**RECEIVE AND FILE COMMUNICATION FROM THE  
PLAN AND ZONING COMMISSION REGARDING  
PRELIMINARY PLAT "LEVEL" ON PROPERTY LOCATED  
AT 220 MAPLE STREET**

Communication from the City Plan and Zoning Commission advising that at their meeting held December 19, 2019 the following action was taken regarding a request from Bridge District II, LLC (owner) represented by Kris Sadoris (officer) for review and approval of the following for property located at 220 Maple Street: A) Review and approval of a Preliminary Plat "Level" to allow Outlot C of Bridge District Plat 2 to be re-platted as a development lot. B) Review and approval of a PUD Development Plan for "Level", to allow development of a 5-story, 121-unit multiple-family dwelling with 53 indoor parking spaces and 153 surface off-street parking spaces.

## STAFF REPORT TO THE PLANNING COMMISSION

PRELIMINARY - NOT FOR CONSTRUCTION  
**LVL - BRIDGE DISTRICT**  
 \*\*\*ADDRESS\*\*\*  
 2016.41  
 P-2 SUBMISSION  
 2016.11.20  
 PERFORM SCHEDULE DESCRIPTION DATE  
 BUILDING ELEVATIONS  
**URDB**

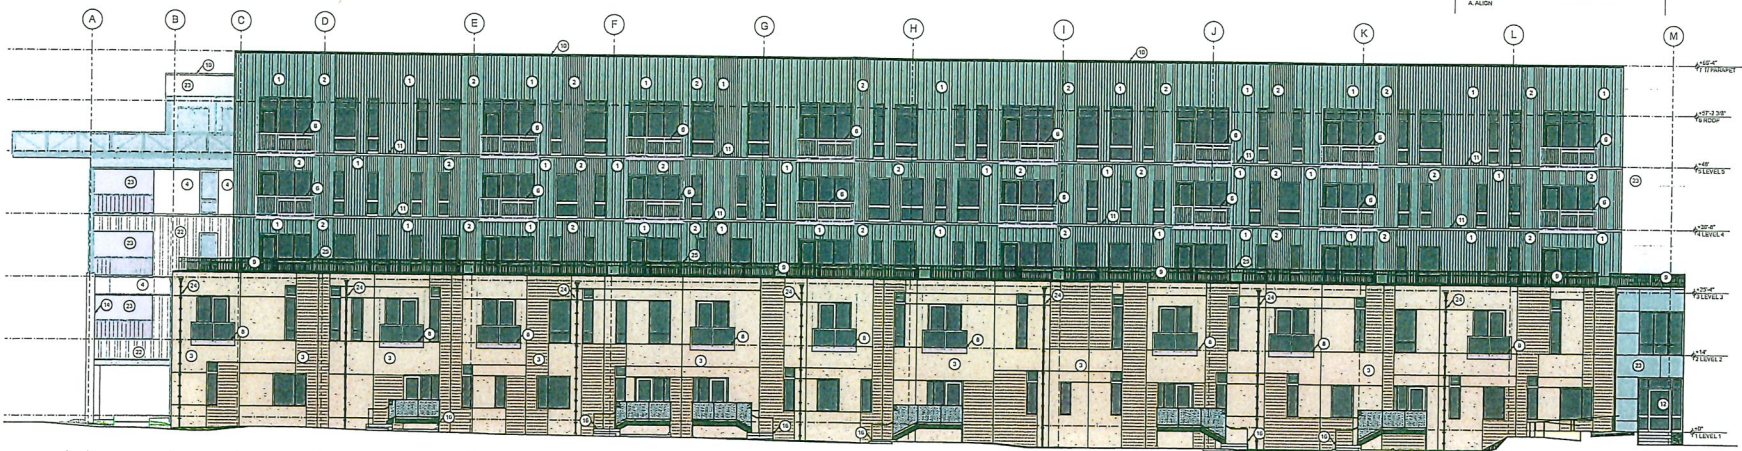
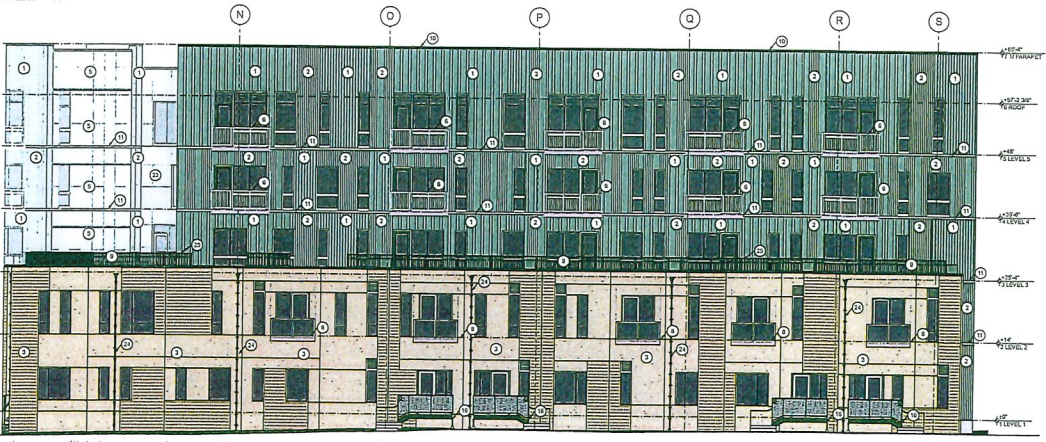
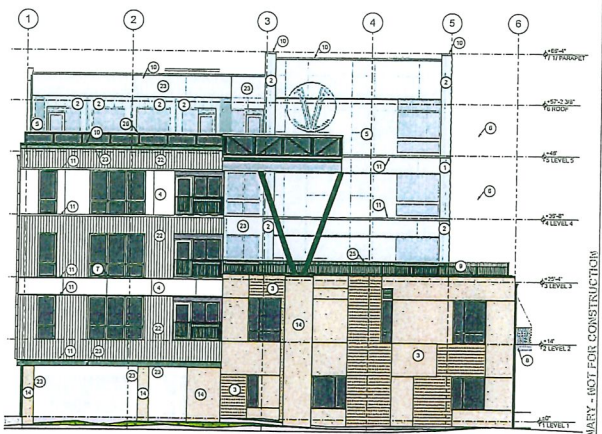
*Staff believes that the proposed building would be compatible with the character of the existing buildings in the Bridge District PUD. Staff recommends approval subject to review of the finalized building elevations and materials by the Planning Administrator. This will allow staff to work with the applicant on any changes that the City's Urban Design Review Board requires.*

*The proposed building would be clad with a mix of precast panels, metal panels and cement board, which complies with these standards.*

*Given the high visibility this building will have from all directions, staff believes that screening needs to be provided on all sides of any rooftop mechanical equipment.*

9. Review and approval of the finalized building elevations and materials by the City's Planning Administrator.
